1. Reason for Report

- 2.1 This application seeks listed building consent for the retrospective installation of a flue pipe and associated re-rendering of the building.
- 2.2 This application relates to a 2 and a half storey, Category C-listed building, situated within Fraserburgh Town Centre Conservation Area and defined town centre, consisting of a takeaway and cafe on the ground floor. The surrounding area consists of retail units, residential properties and a residential care home. The property sits on the north-east corner of a cross-roads, incorporating Commerce Street and Cross Street.

West Elevation : Scale 1 : 100

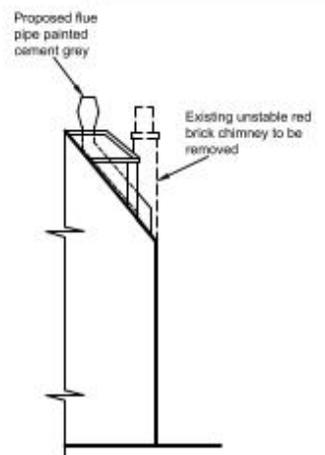
- 2.4 The proposed flue services the ground floor takeaway, which protrudes from the west-facing roof elevation, and extends upwards the full elevation of the west facing roof, parallel to the pitch and rises vertically above the ridge height, resulting in an approximate full length of the proposed flue of 3.5m, and protrudes approximately 0.7m above the ridge of the slate roof. This retrospective development removed the red brick chimney (mentioned above),

- 6.5 The large flue has been painted in an attempt to address the visual concerns of the proposal, however, this does not mitigate the adverse visual impact of the flue on the front facing elevation of the listed building arising due to its obtrusive position, design and scale. Infrastructure Services (Environment – Built Heritage) do not find this aspect of the proposal acceptable and commented that as the large flue is located in such a prominent location, on the front of the building, the proposed flue is not considered to be appropriately designed and sited. . If positioned in such a prominent position on the building, a more sympathetic design of a replacement masonry chimney would be a more discrete and suitably designed option in terms of material choice, design and scale, which would not impact upon visual amenity. This was requested by the Planning Service, however no amendments with regards to this were provided. It must also be noted that Listed Building Consent was not sought for the removal of the red brick chimney, which the Planning Service would have recommended repairs to rather than its removal. Therefore, the material choice of a contemporary, metal flue is not considered acceptable in the historic environment and a masonry chimney would have been the preferred choice to uphold the traditional style.

- 6.6 The listed building is situated in a prominent location within the Fraserburgh Town Centre Conservation Area the proposed flue would have a significant adverse impact on the appearance and character of Conservation Area and listed building, in that the siting, materials and design would not be sympathetic to the historic setting and can therefore not be supported under policies HE1 and HE2.

01. The proposed flue is considered to be inappropriately designed, finished in a modern and unsympathetic material incompatible with the traditional building, and is unsuitably scaled and positioned on a prominent elevation resulting in an adverse visual impact on the streetscene and reducing the historic and traditional merit of the Category C-listed building, contrary to Policies HE1: Protecting historic buildings, sites and monuments and HE2: Protecting historic and cultural areas as contained in the Aberdeenshire Local Development Plan 2017. This would negatively impact upon the character of the building and wider Conservation Area, undermining the positive contribution the principal elevation of a building would have and undermines the integrity of the Listed Building and Conservation Area designations.
